Access Compliance Report

Public Rights-of-Way

(Curb Ramps)

Intersection ID: 22882	Main Street: SARDIS_POINTE_RD	Cross Street: SARDIS_RD	Location: S
ADA ID: ED47E64A6A10	Ramp Type: Perp	Initial Pass/Fail: Fail	Overall Compliance: No
Severity Score: 33.75			
Codes/Mitigation Info/Possible Solution		Field Measurements/Component Compliance

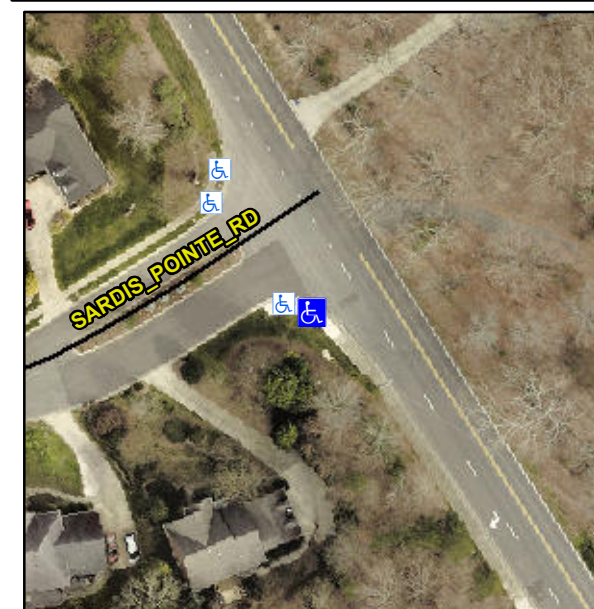
R304.5.1, R304.5.3

Compliance	Description	Data	Compliance	Description	Data
N/A	Ramp Length (in)	71.0	Yes	Ramp Slope (%)	5.1
No	Ramp Width (in)	46.0	No	Ramp XSlope (%)	8.1
N/A	Flare Type LT	N/A	N/A	Flare Type RT	N/A
N/A	Flare Slope LT (%)	N/A	N/A	Flare Slope RT (%)	N/A
N/A	Flare Traversable LT?	N/A	N/A	Flare Traversable RT?	N/A
N/A	Landing Length (in)	N/A	N/A	DWS Provided?	N/A
N/A	Landing Width (in)	N/A	N/A	DWS Contrast?	N/A
N/A	Landing Slope (%)	N/A	N/A	DWS Length (in)	N/A
N/A	Landing X Slope (%)	N/A	N/A	DWS Full Width?	N/A
N/A	Landing Curb? (Y/N)	N/A	N/A	DWS Offset (in)	N/A
N/A	Shared Landing?	N/A			
N/A	Gutter Ponding?	N/A	N/A	Gutter Slope (%)	N/A
N/A	Gutter Lip Ht (in)	N/A	N/A	Gutter X Slope (%)	N/A
N/A	Painted X Walk1?	No	N/A	Painted X Walk2?	N/A
	X Walk 1 Direction	To NE		X Walk 2 Direction	N/A
N/A	X Walk 1 Width (in)	N/A	N/A	X Walk 2 Width (in)	N/A
	X Walk 1 Slope (%)	7.0		X Walk 2 Slope (%)	N/A
	X Walk 1 X Slope (%)	3.7		X Walk 2 X Slope (%)	N/A

Remove & Replace Entire Ramp.
